February 27, 2014
Serial: MNS-14-023

Subject: Second Six-Month Status Report in Response to March 12, 2012, Commission Order Modifying Licenses with Regard to Reliable Spent Fuel Pool Instrumentation (Order Number EA-12-051)

McGuire Nuclear Station Response to Spent Fuel Pool Instrumentation
Interim Staff Evaluation Request for Additional Information Regarding
Overall Integrated Plan for Implementation of Order EA-12-051.

UNIT 1
FIGURE 1
PRIMARY LEVEL CHANNEL CABLE ROUTE PLAN
SIGNAL CABLE
SPENT FUEL POOL
EL. 767'

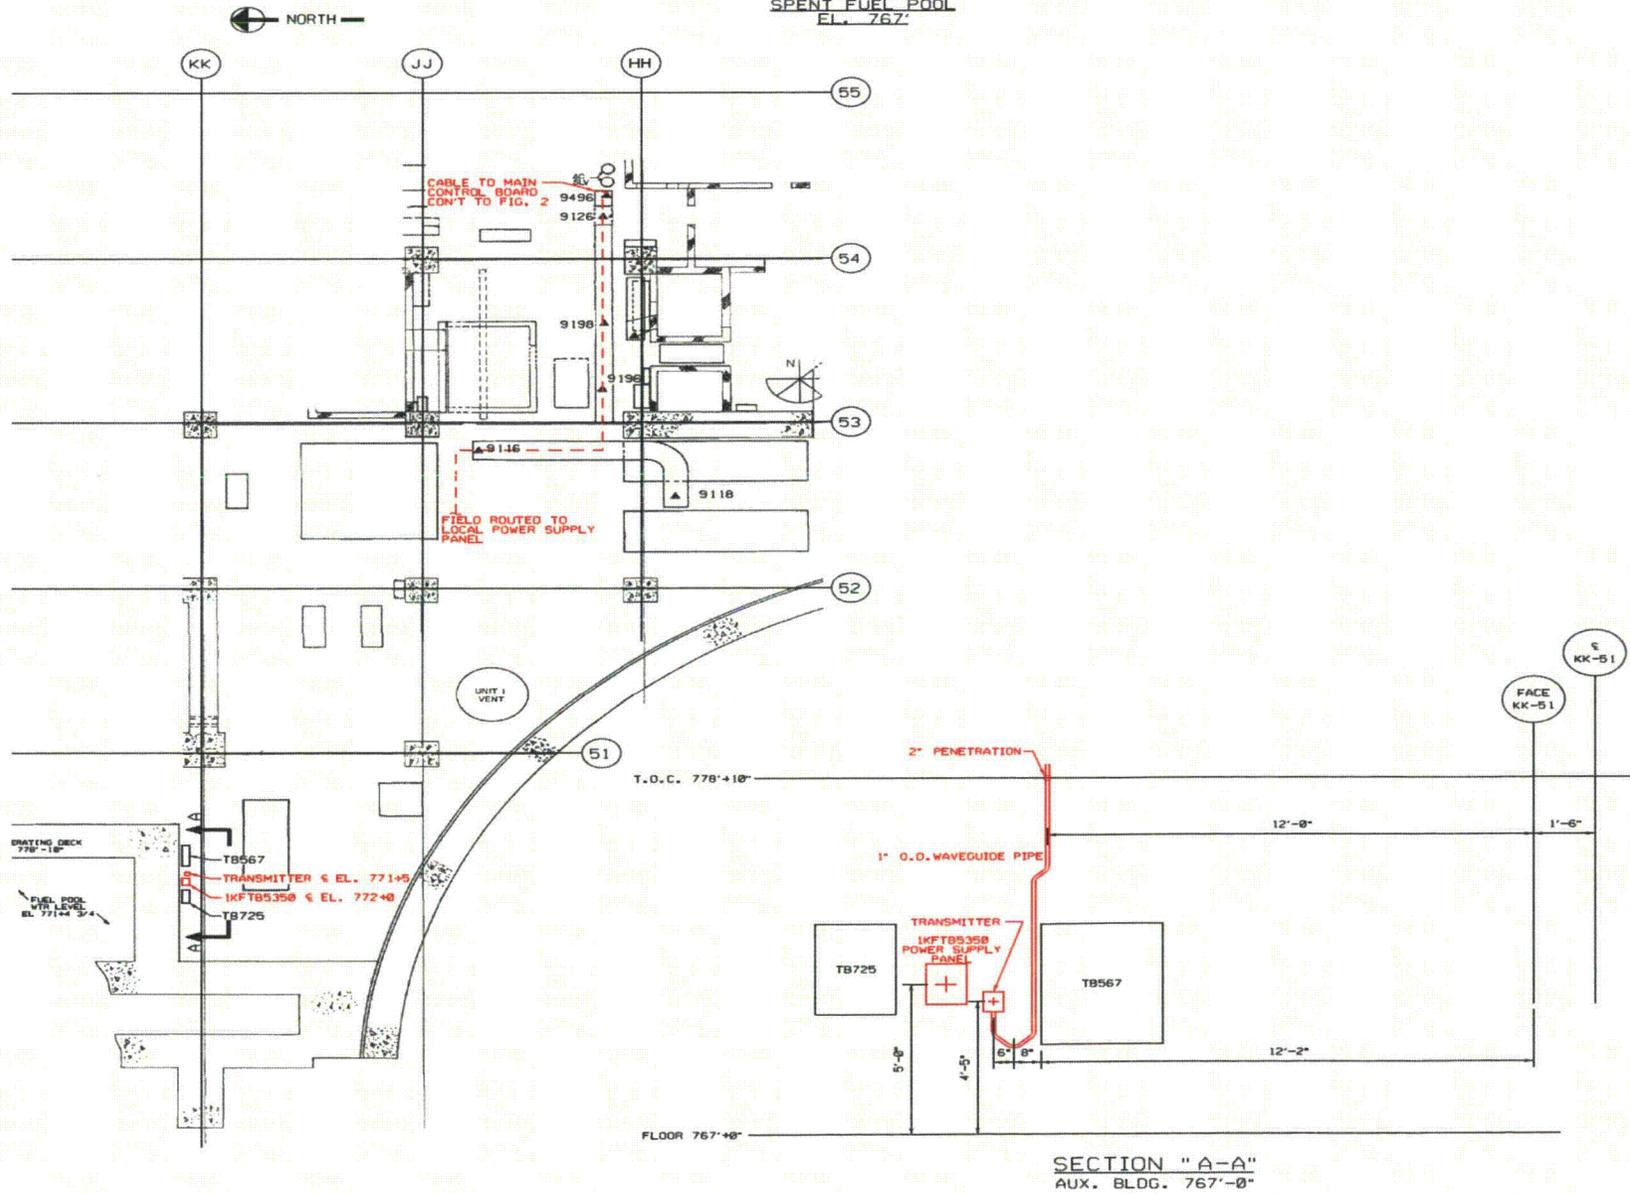
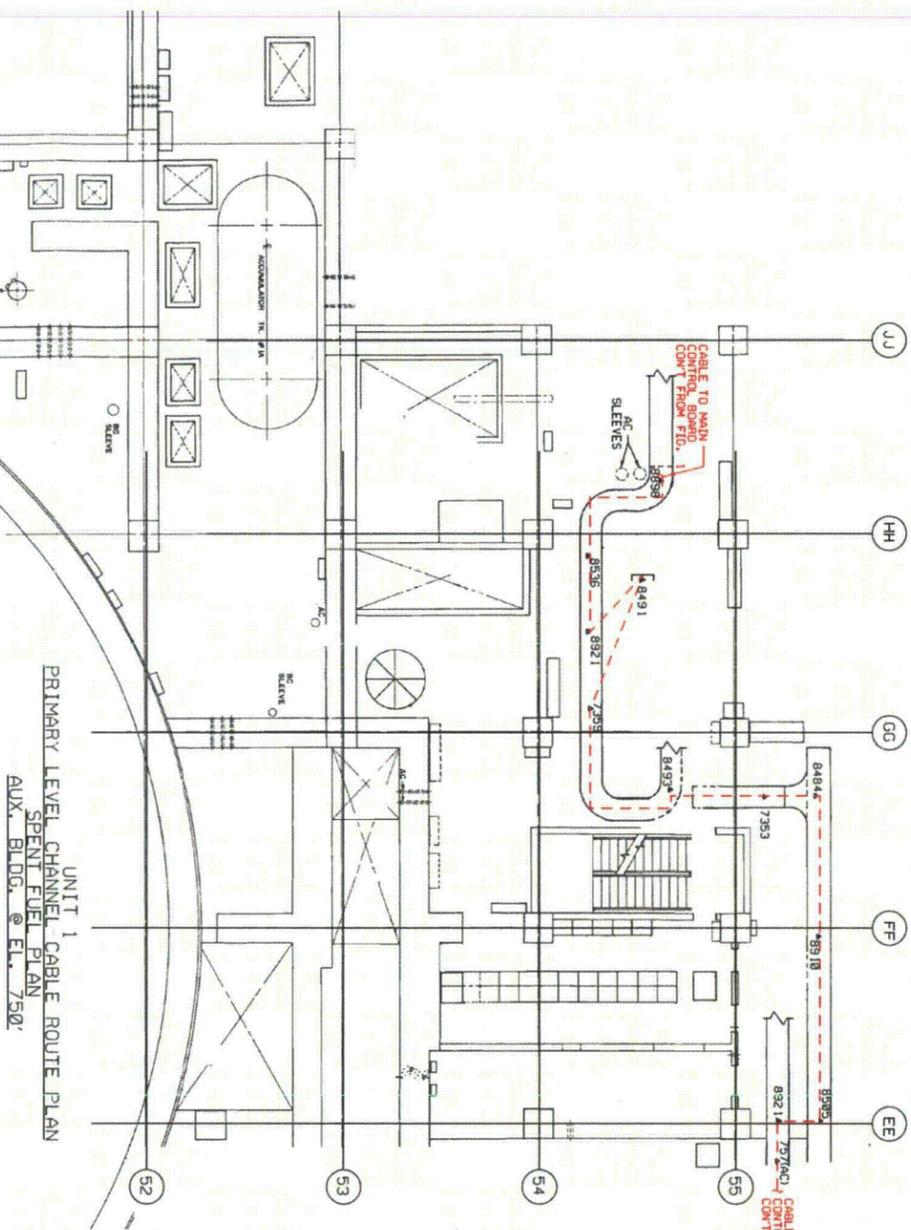
Please provide additional information describing how the proposed final arrangement of the primary SFP level instrumentation and routing of the cabling between the level instruments, the electronics and the displays, meets the Order requirement to arrange the SFP level instrument channels in a manner that provides reasonable protection of the level indication function against missiles that may result from damage to the structure over the SFP.

The planned routing for the primary level channel cabling is depicted in Figures 1-4 and Figures 5-8 for Units 1 and 2, respectively. Figures 2 and 7 depict the relative proximity of the back-up channel components to the primary channel components.

UNIT 1
BACK-UP LEVEL CHANNEL CABLE ROUTE PLAN
SPENT FUEL POOL
REACTOR BLDG. @ EL. 725'

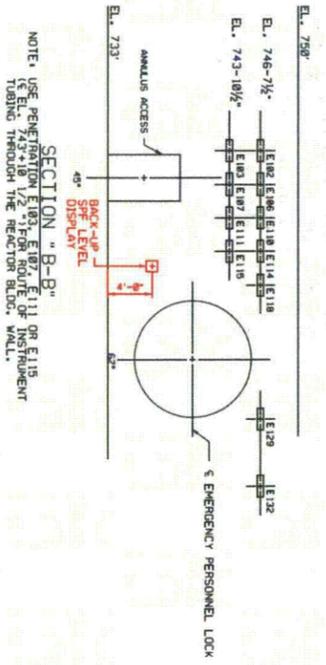
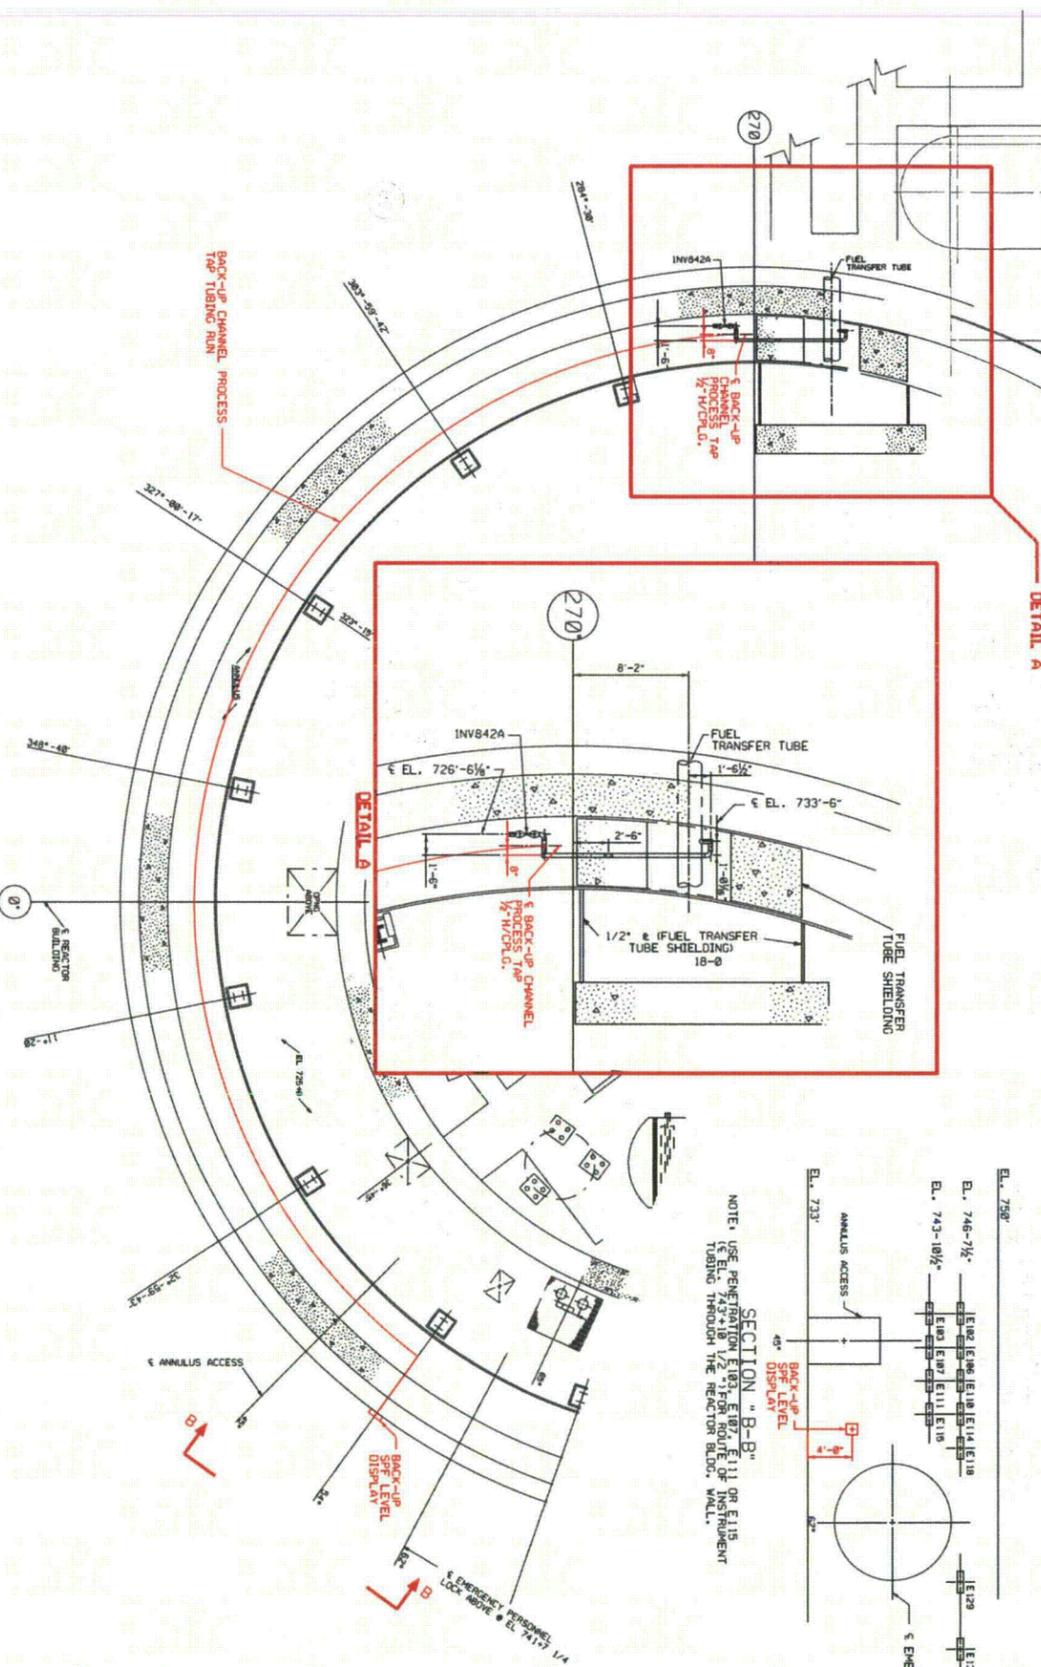
Please provide a clearly labeled sketch or marked-up plant drawing of the plan view of the SFP area, depicting the SFP inside dimensions, the planned locations/placement of the primary and back-up SFP level sensor, and the proposed routing of the cables that will extend from the sensors toward the location of the read-out/display device.

As noted in the prior July 11, 2013 McGuire RAI response, the back-up channel is purely a mechanical pressure gauge device which is remotely located from any of the primary channel components and cabling. The back-up channel sense-line tubing is routed through the Reactor Building annulus area (725' floor elevation) to the read-out display/gauge in the Auxiliary Building (733' floor elevation). The back-up channel does not require power/signal cables or any power supply. The back-up channel components are spatially separated from the primary channel components/cabling by Seismic Category I structure floors and walls. The design of the back-up level channel is spatially separate and electrically independent from the primary channel, whereby potential common mode failures are precluded.

FIGURE 9
SCHEMATIC LAYOUT DRAWING FOR
MNS UNIT 1
VEGA WAVEGUIDE PIPE, TRANSMITTER,
VEGAPULS 62ER SENSOR, AND
MOUNTING SUPPORTS

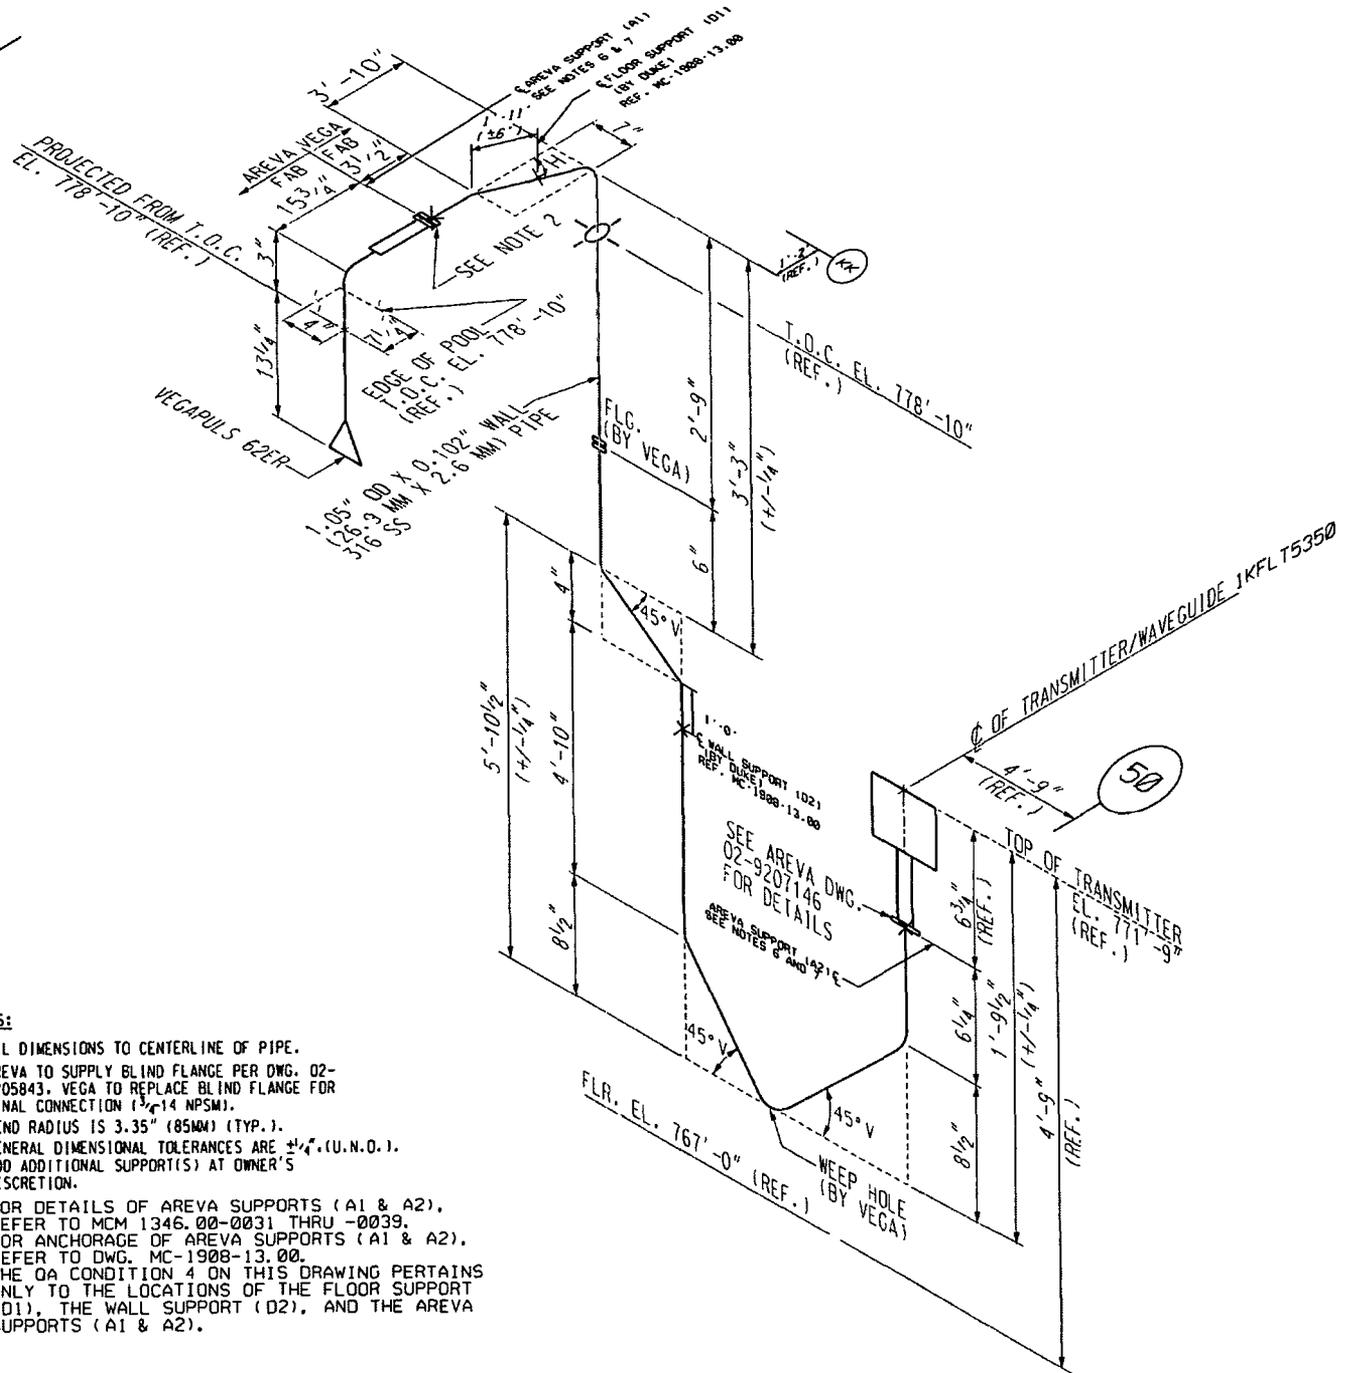
- b) A description of the manner in which the level sensor (and stilling well, if appropriate) will be attached to the refueling floor and/or other support structures for each planned point of attachment of the probe assembly. Indicate in a schematic the portions of the level sensor that will serve as points of attachment for mechanical/mounting or electrical connections.**

The wave guide piping assembly, horn, and electronic sensor are designed to attach to the SFP concrete floor and the Auxiliary Building concrete wall by means of mounting supports. These mounting supports consists of a sensor support, horn support, and intermediate supports. Spacing of the mounting supports comply with site specific specifications and standards and qualification restrictions for the wave guide pipe assembly. Figures 9 and 10 depict the planned attachment points for the wave guided piping and horn assembly for Units 1 and 2, respectively.
